**Arboricultural report on trees on and adjacent to a proposed
development site at 144 Mill Lane London NW6 1TF**

December 2018

Sylvan Resources Ltd. forestry and arboriculture

Project/Site			
144 Mill Lane, London			
Drawing Title			
SR2 - Tree Removal			
Drawing no	Rev	Scale	Date
	B	1:100 (A3)	11/01/2019

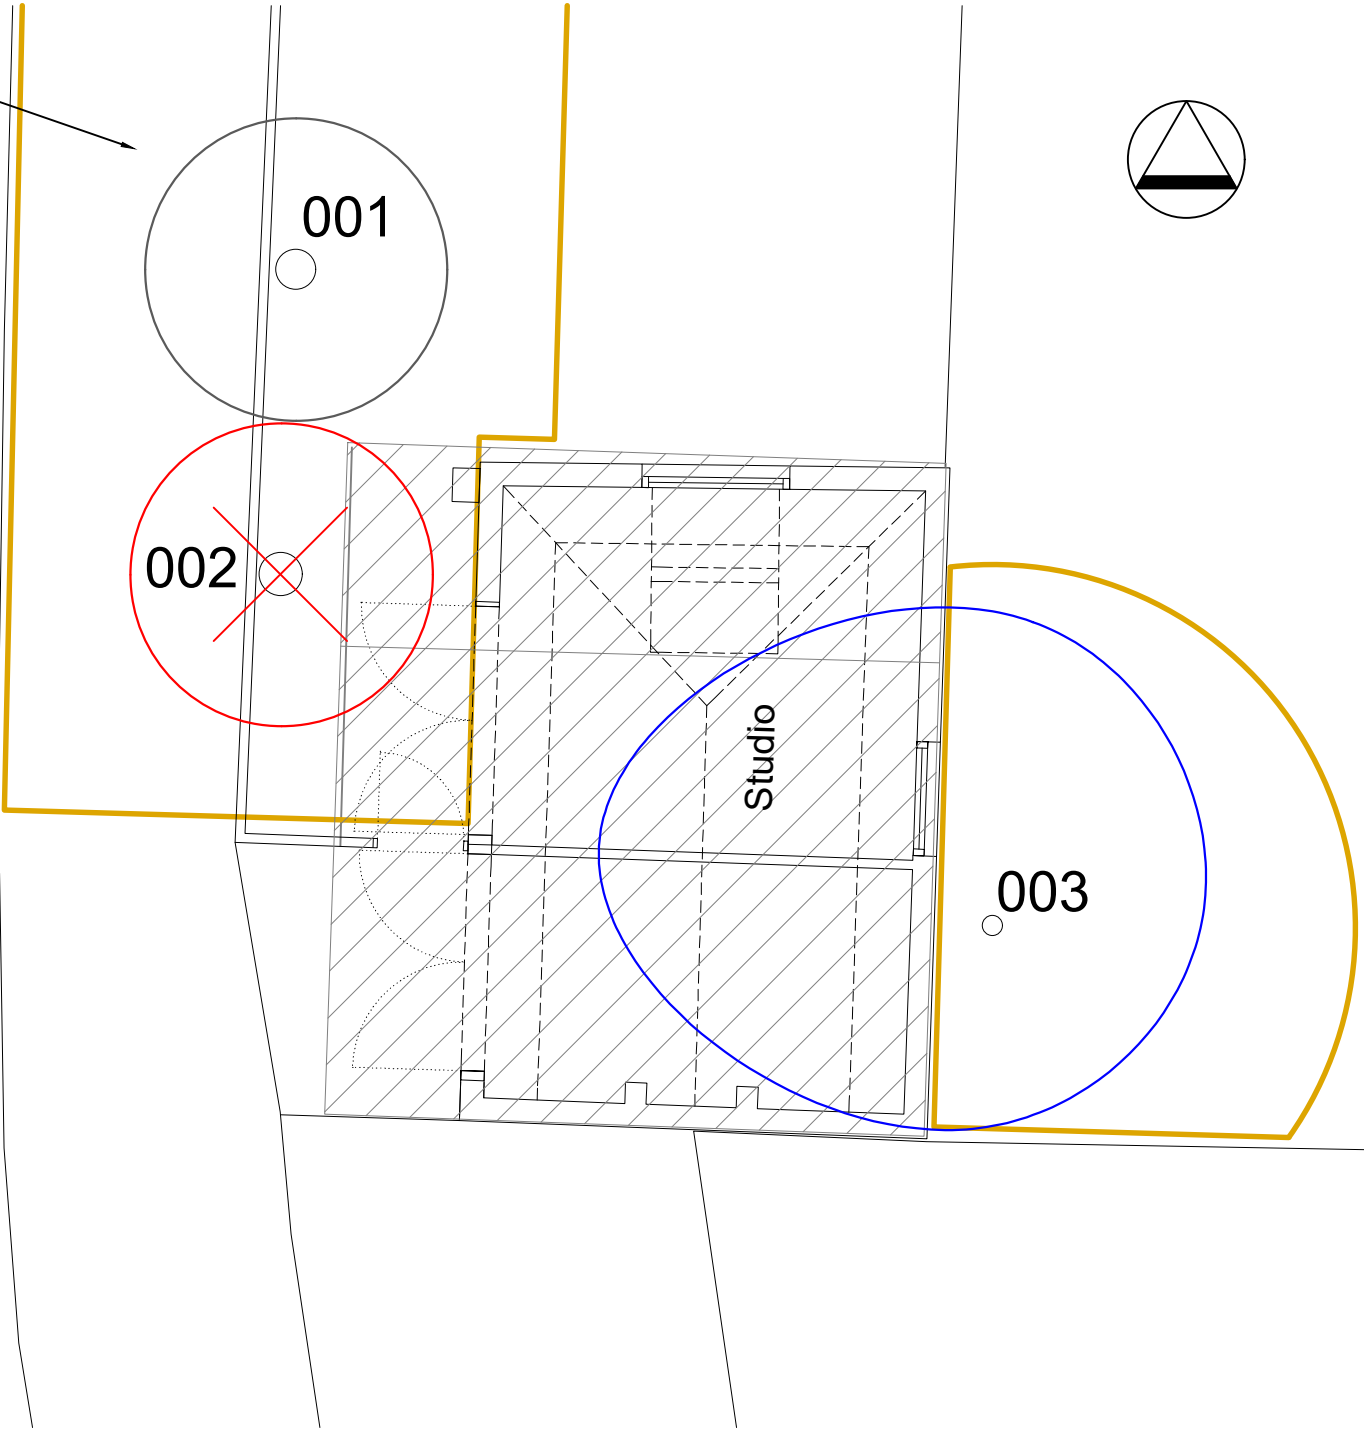
- 4.1.3 In my opinion consideration should also be given to the removal of Tree 001. This is a poor-quality specimen which provides little amenity benefit. The tree could be replaced with another species whose mature height is smaller than a Lime tree's and therefore more in scale with the local environment.

Consider removal of Tree 1

- 5.3.1 Tree 001, (subject to consent) and 002, shall be removed before other site work begins. Their locations are shown on the tree removal plan (Appendix A). The work shall accord with BSS 3998:2010 Recommendations for Tree Work. It shall be carried out by an appropriately qualified arboriculturalist. Arisings shall be removed to an approved tip. Stumps may be ground or dug out.

TREE CONSTRAINTS PLAN

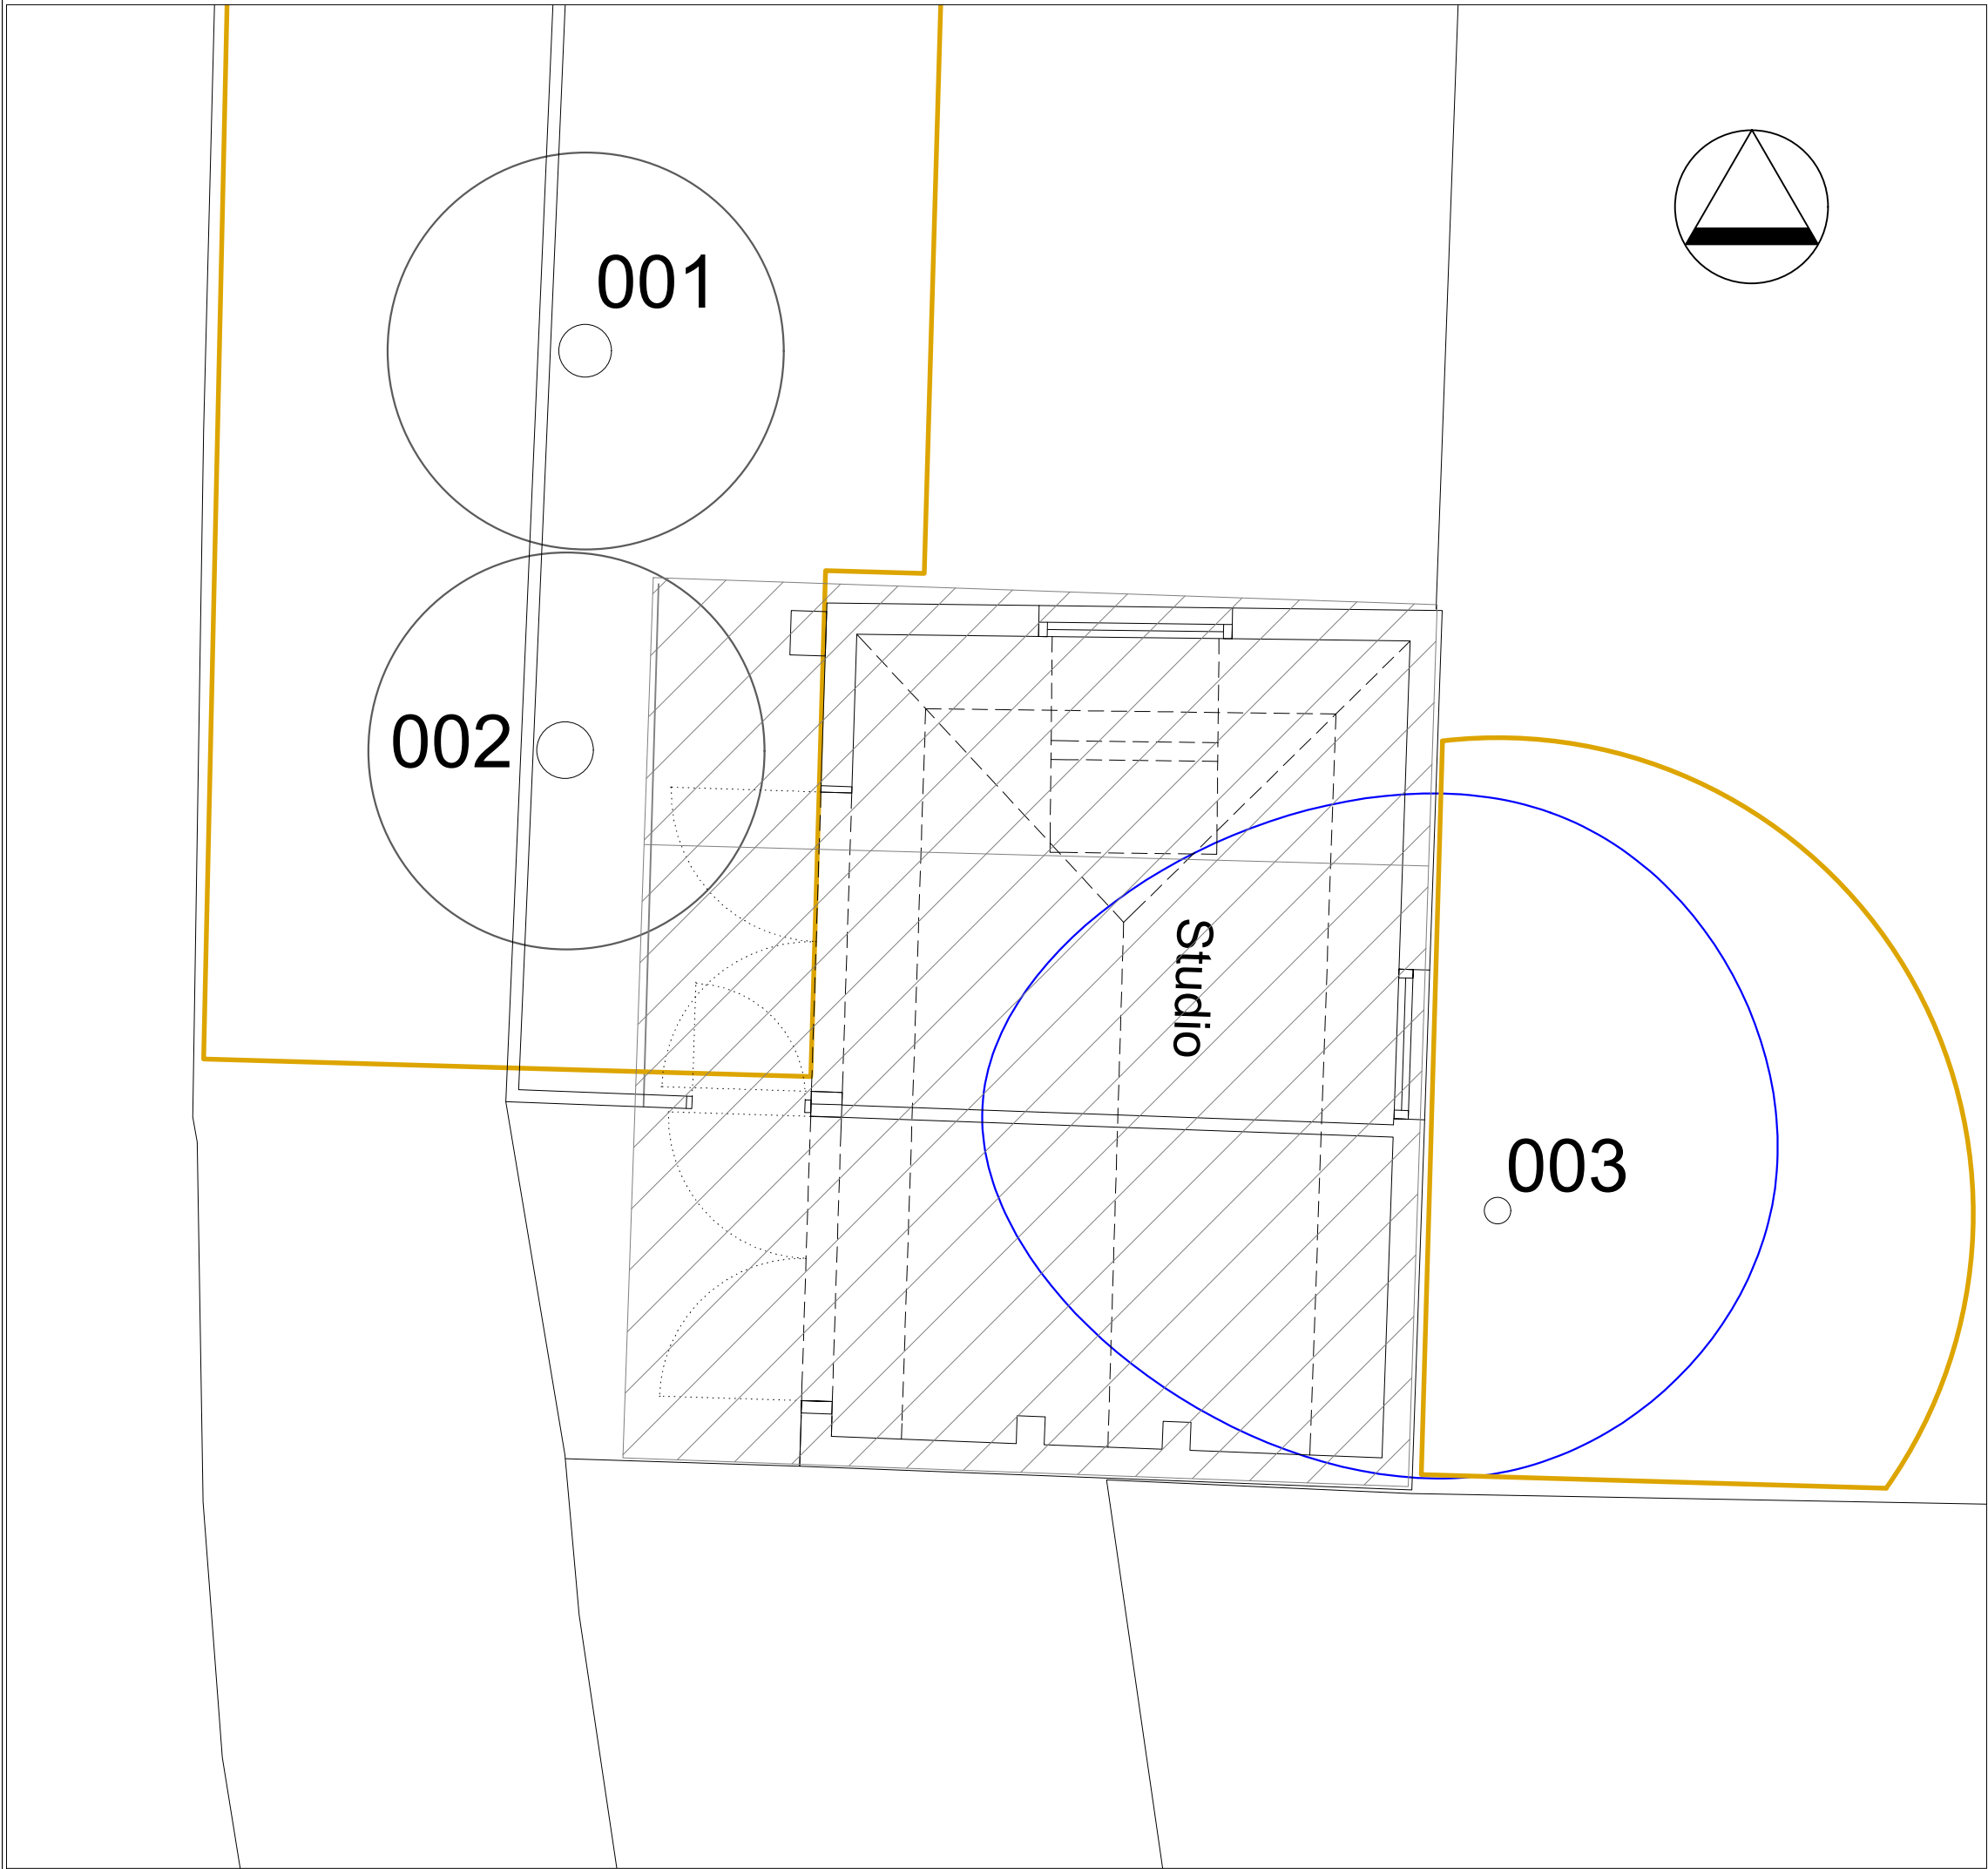
- 4.2.3 I agree that the RPAs of both trees coalesce to form a single combined RPA.
- 4.2.4 In my opinion the RPA of Tree 001 is more likely to extend northwards rather than southwards into the RPA of Tree 002 as drawn by Mr Skerratt. The combined RPA south of Tree 001 is smaller than that to the north and east of this tree.

- 4.2.5 The south part of the combined RPA is occupied by Tree 002. Its roots will be occupying this part of the combined RPA and extending northwards towards and into the RPA of Tree 001.

- 4.2.6 Because of its restricted nature, there will be heavy competition within the south part of the combined RPA. For this reason, I consider it unlikely that Tree 001 will have rooted into the area occupied by Tree 002.
